Rezoning Transportation Analysis

Petition Number: 2023-012

Date	Description
5-24-23	First Review (PDM)
6-21-23	Second Review (DR)

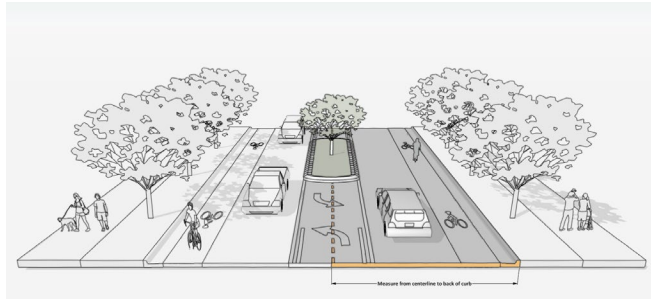
- a. **Speer Boulevard (Shopton Rd Extension):** Location of curb and gutter to be installed 18.5 feet from roadway centerline to the back of curb to accommodate the Charlotte Streets Map with a roadway typical section of a 2 avenue with bike lanes, 8-foot sidewalk and 8-foot planting strip.

- b. **Yorkmont Road:** Location of curb and gutter to be installed 24 feet from roadway centerline to the back of curb to accommodate the Charlotte Streets Map with a roadway typical section of a 2+ avenue with bike lanes, 8-foot sidewalk and 8-foot planting strip.

Label and dimension the curb and gutter from the centerline for each road on the site plan.

Outstanding Comment from 6.21.23: Label and dimension the curb and gutter from the centerline for each road on the site plan.

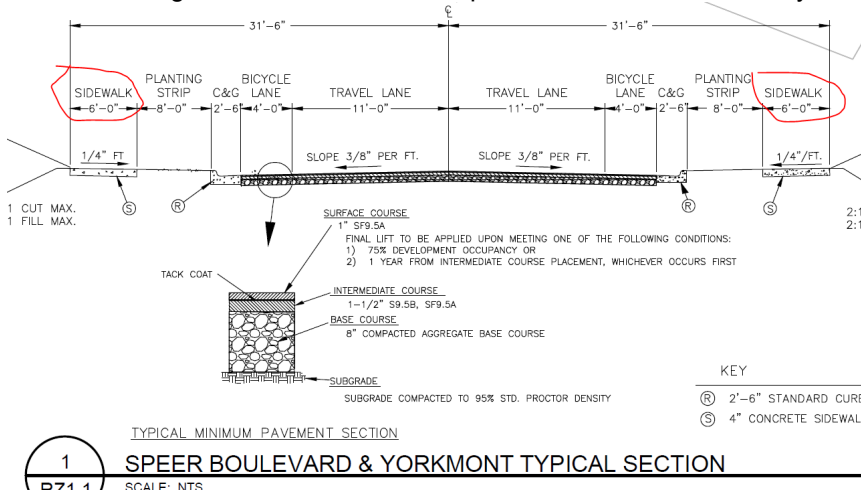
3. Revise site plan and conditional note(s) to commit to dedicate a minimum of 35 feet of right-of-way from the road centerline on Yorkmont Road and Speer Boulevard. The site plan shall label and dimension the right-of-way from the road centerline.

Clarifying comment 6.21.2023: Add conditional note to dedicate a minimum 35 feet of ROW from the roadway centerline of Yorkmont Road and Speer Boulevard. Additionally label and dimension.

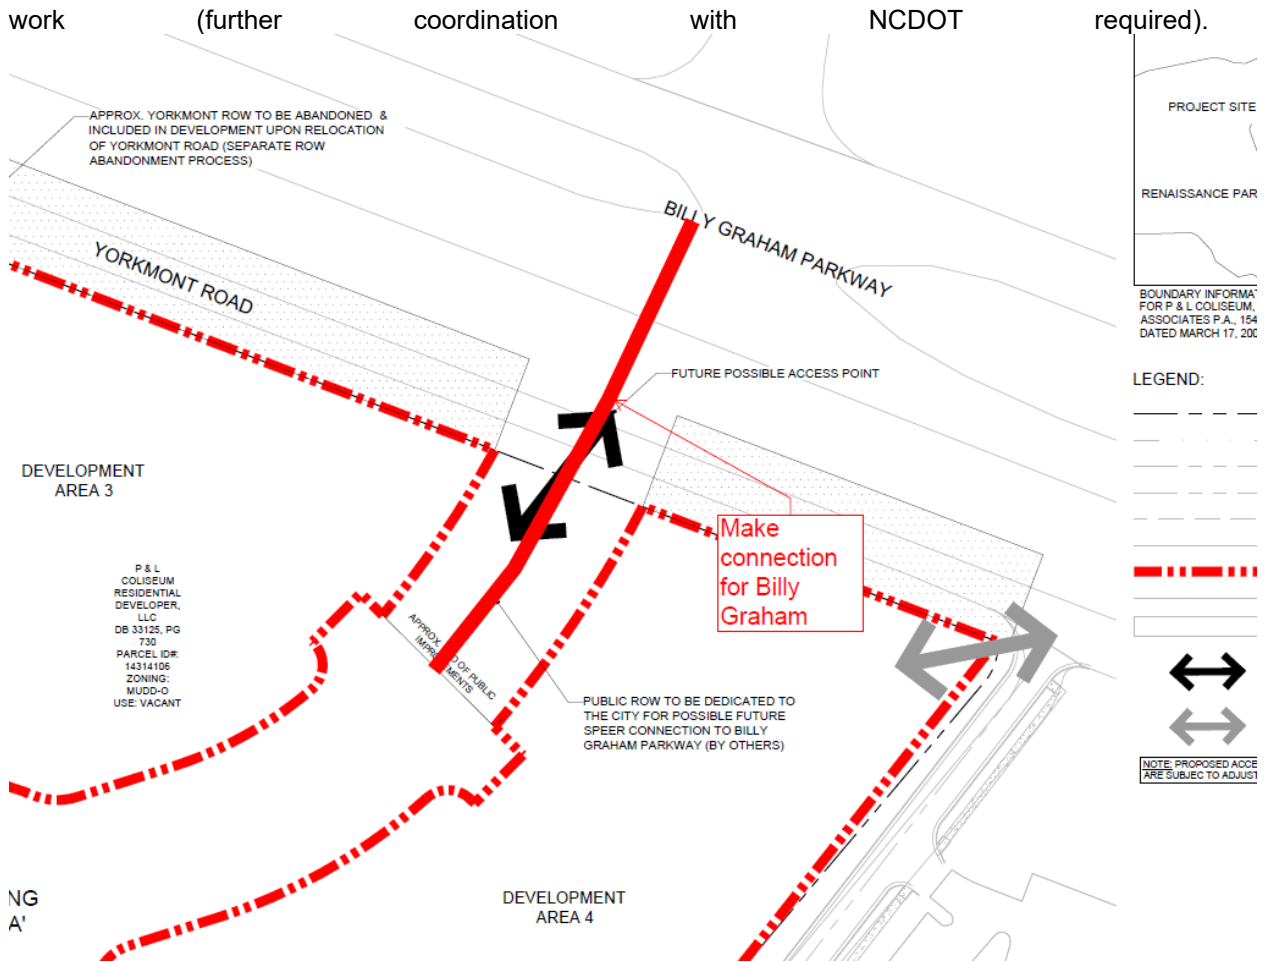
5. Revise site plan and conditional note(s) to commit to construct bicycle facilities by locating the curb and gutter 18.5' on Speer Boulevard and 24' on Yorkmont Road from the center line/installing a bike lane to meet the Council-adopted Charlotte BIKES Policy.

Clarifying comment 6.21.2023: Add conditional note to construct bicycle facilities on Speer Boulevard and Yorkmont Road.
